ADDENDUM NO. 3

Project Name: **JACKIE ROBINSON TRAINING COMPLEX VILLAS REMODEL (IRC-1914A)**

Bid Number: **2022009**

This addendum is released to provide answers to questions received to date, and to replace pages from the Plan Set as noted in "Attachments".

SHEET NO.
A-2
OF SIX

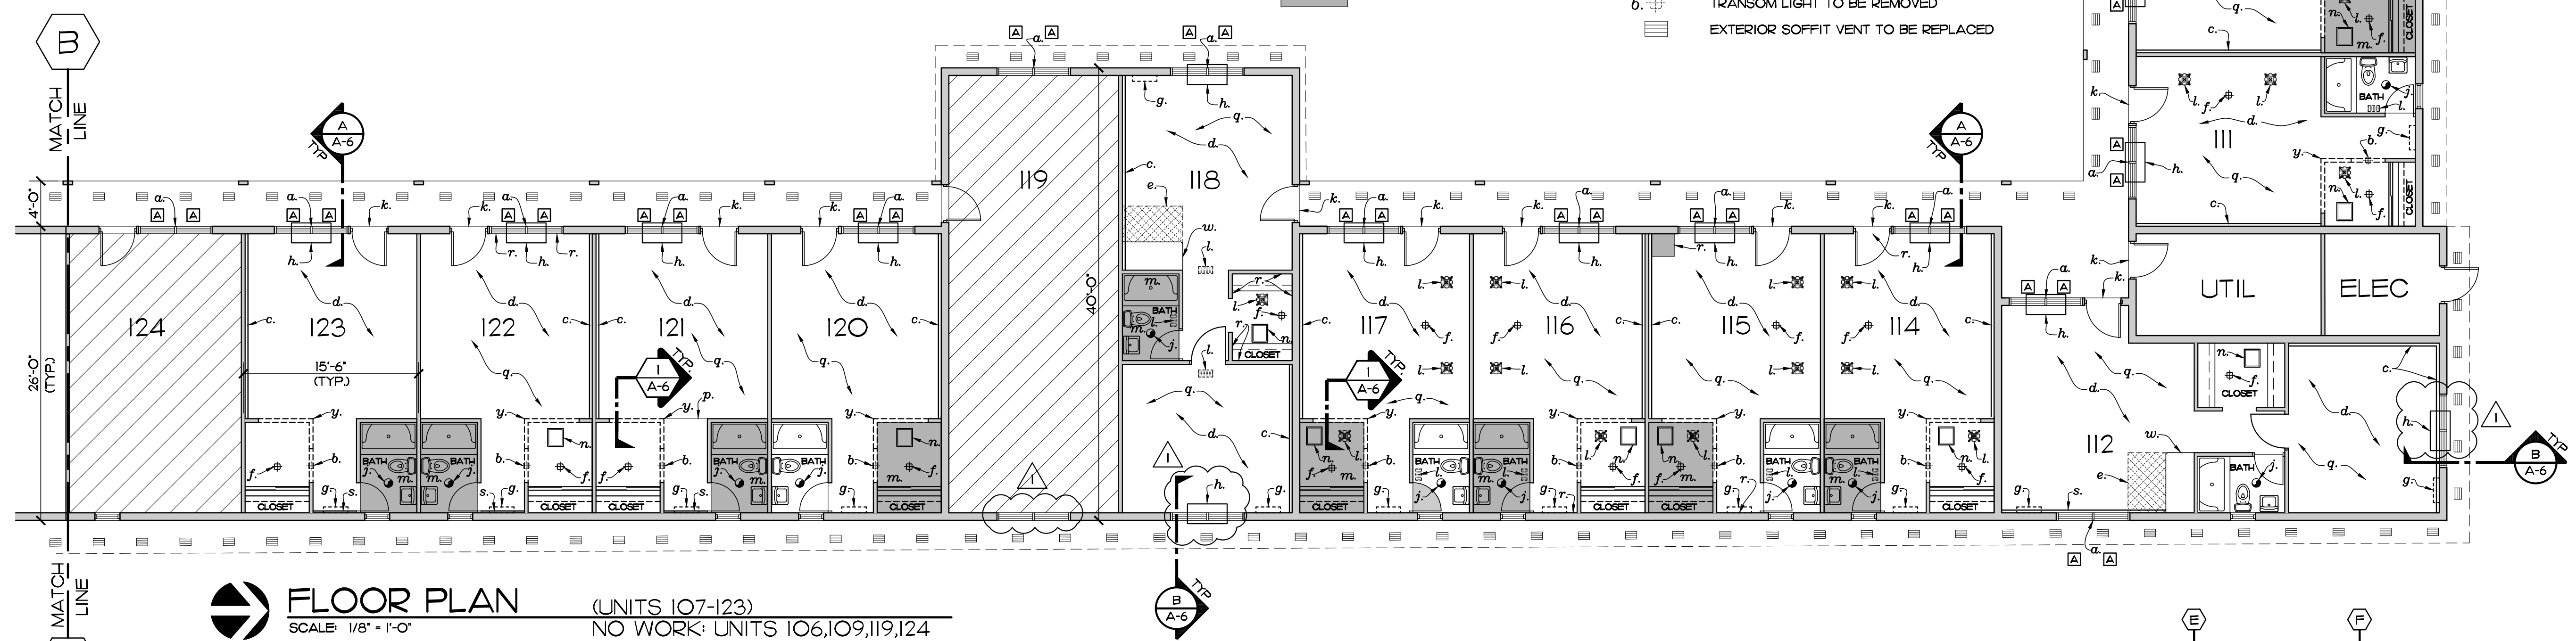
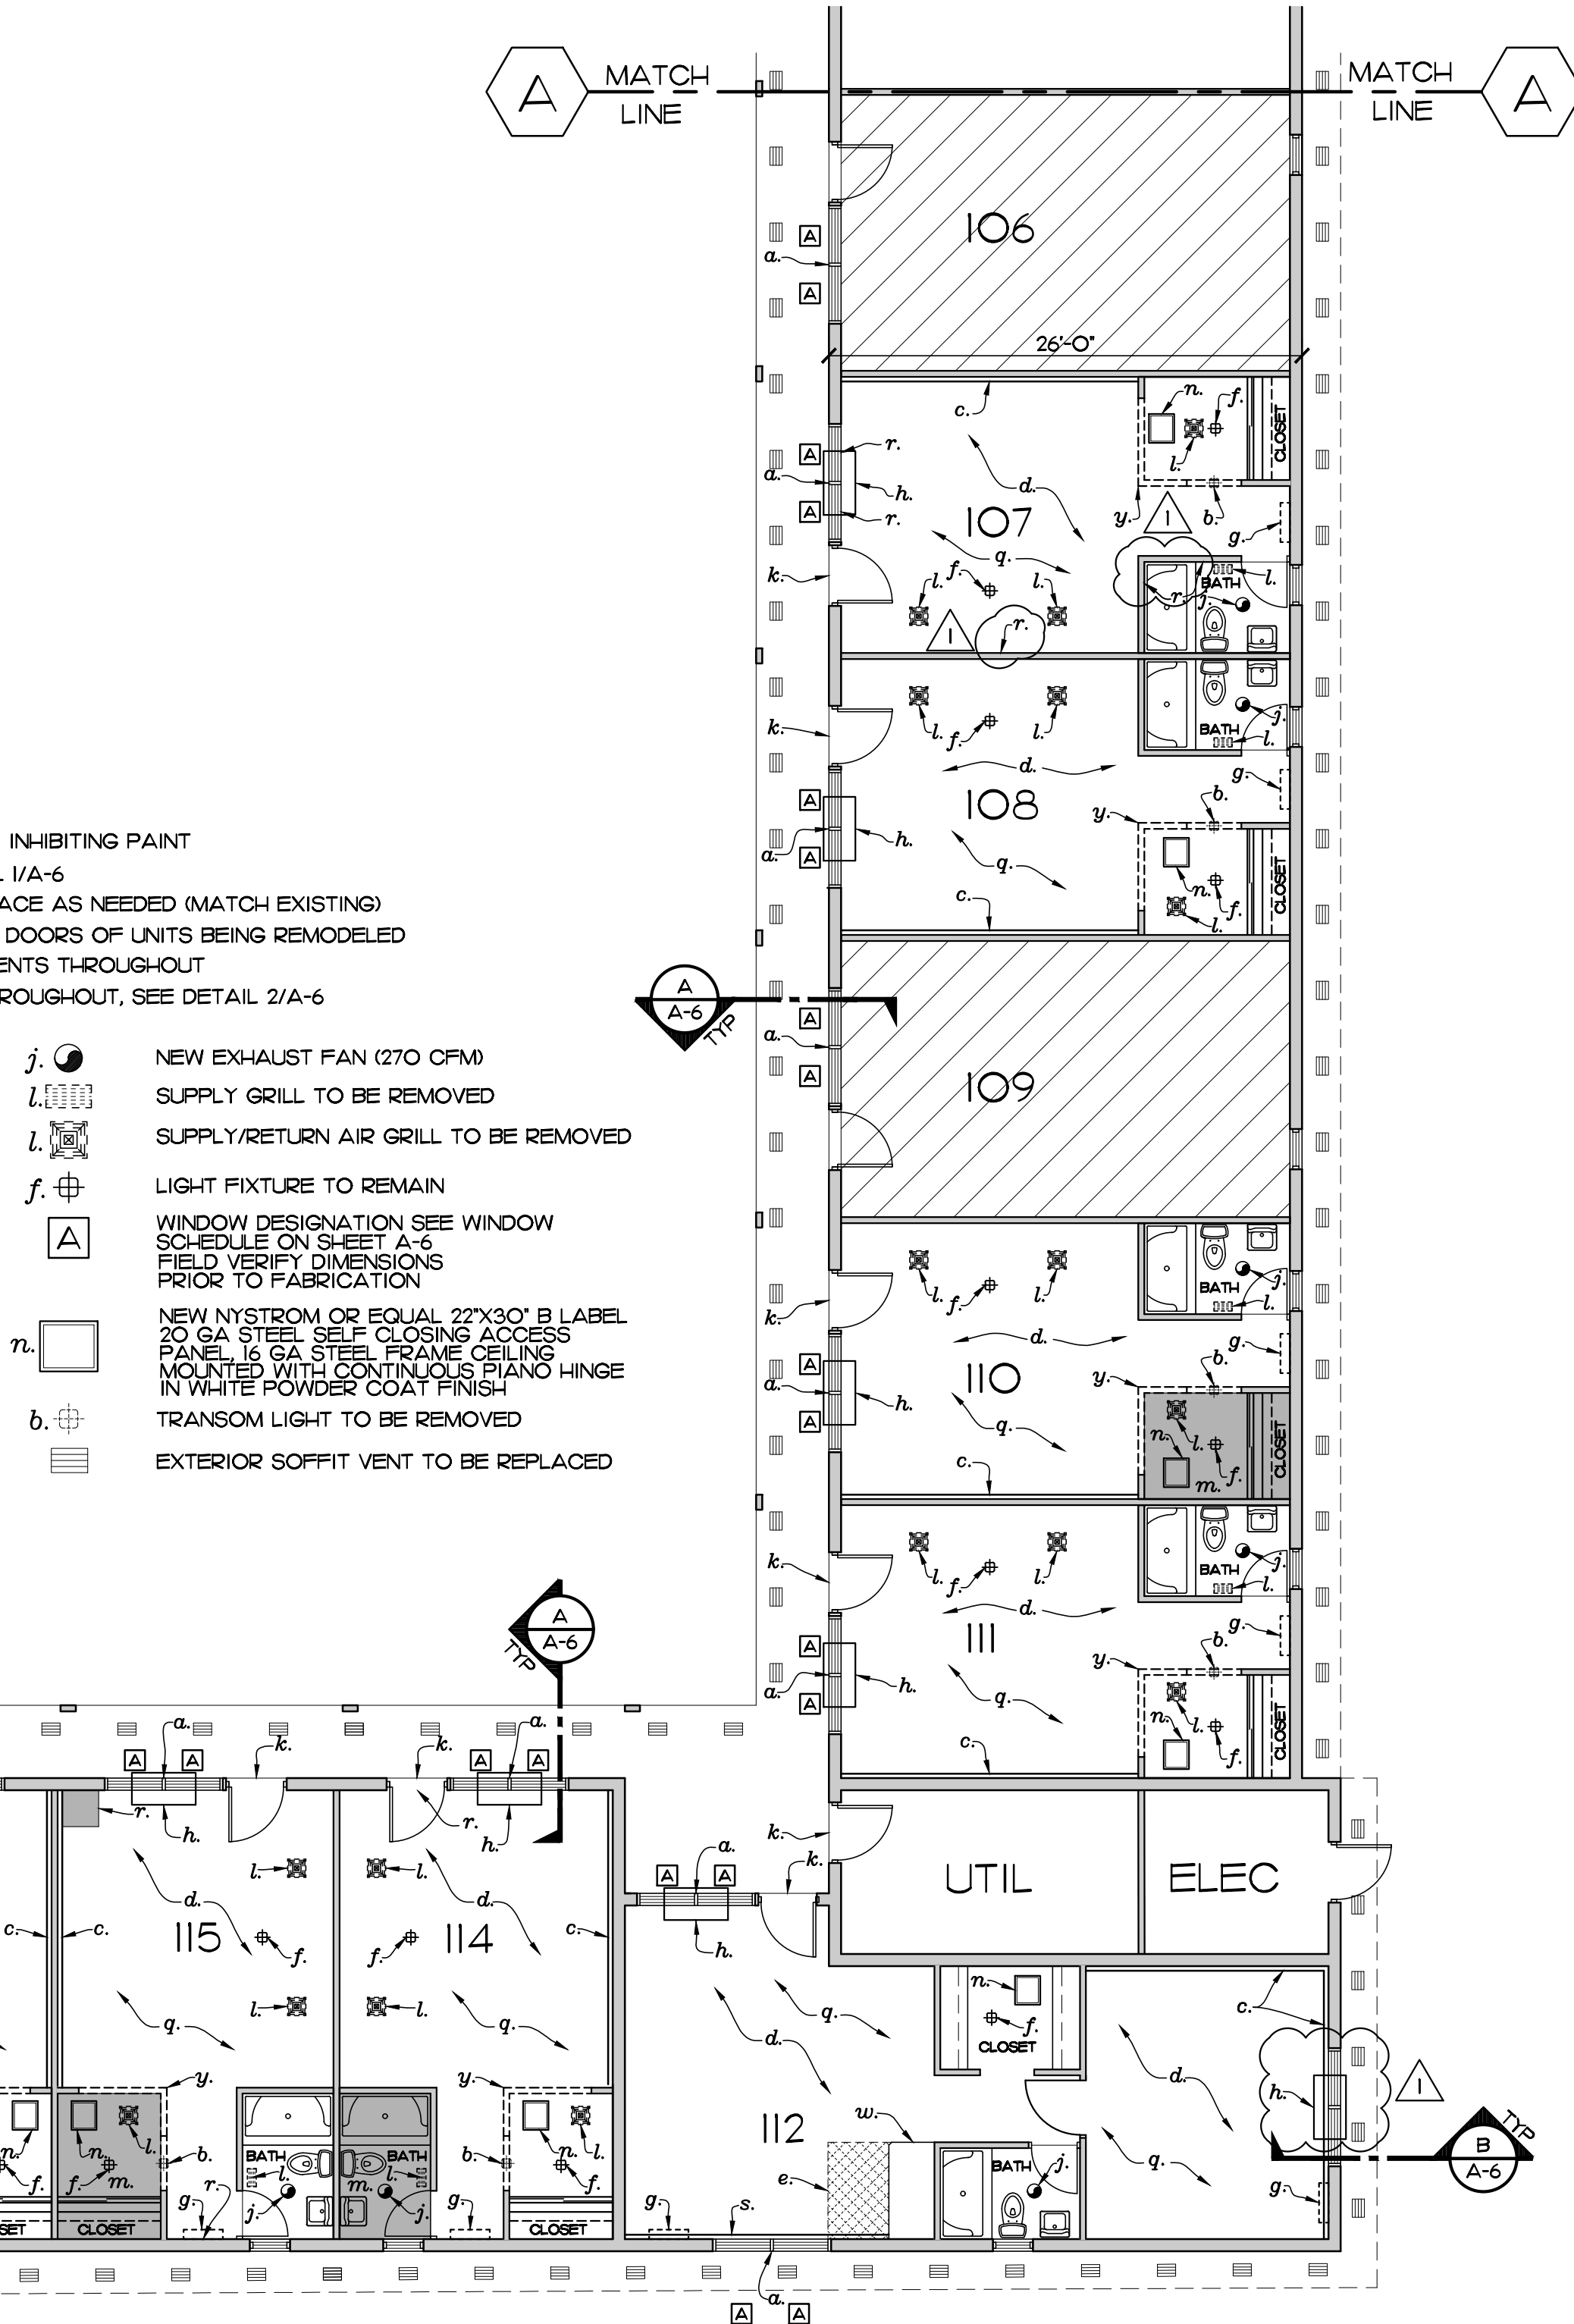
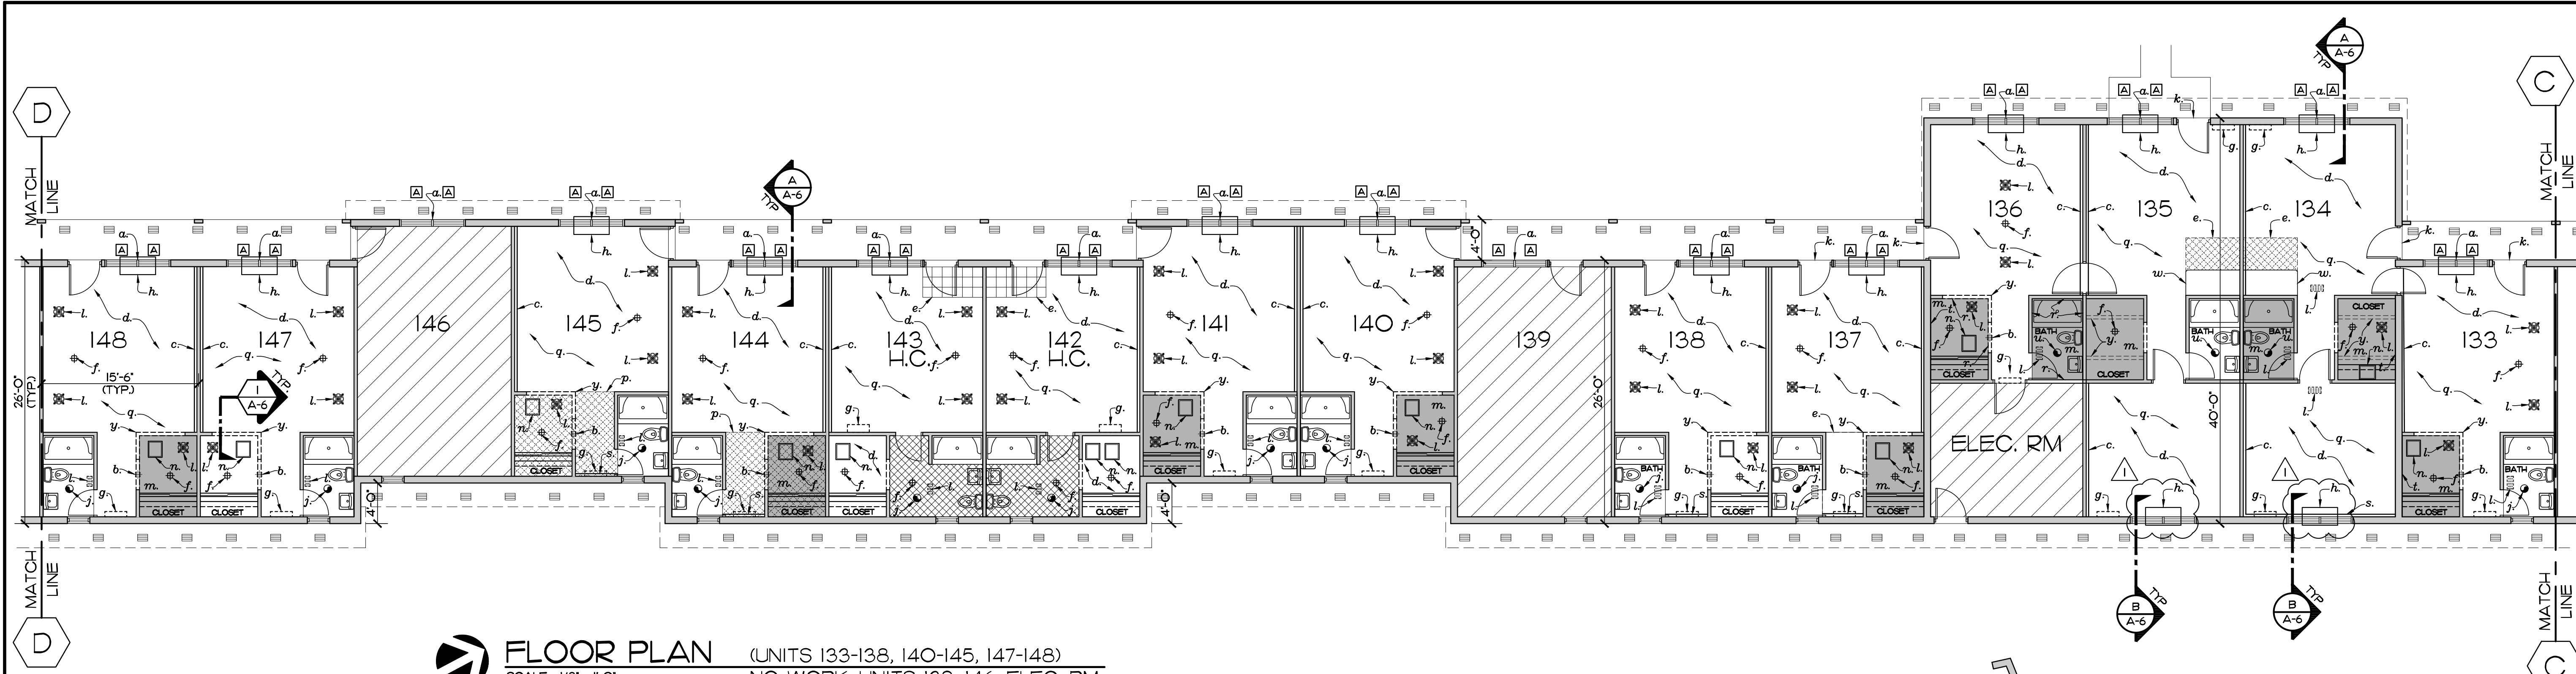
- Architectural plan sheets A-2 thru A-5: The bedroom windows in all of the suites are to remain. These were mis-labeled on plans to be replaced, therefore there will be no change in quantity.
- Sheet A-2 - Additional "r" call-outs have been added to room 107.
- Sheet A-4 – Shading has been added to Kitchen ceilings in rooms 150, 151, 153, and 154. Shading was also added to living room ceiling in room 161.
- Mechanical/Electrical Plans M-1 thru M-4; Trane PTAC unit specified in A/C Equipment schedule is no longer available and has been replaced with a GE PTAC unit, associated electrical notes have been revised.
- Itemized Bid Schedule; Item 1 expanded the description of Mobilization.
- Appendix C - Asbestos Survey Report: Page 4 of report under Drywall System (Texture) the word friable has been replaced with non-friable.
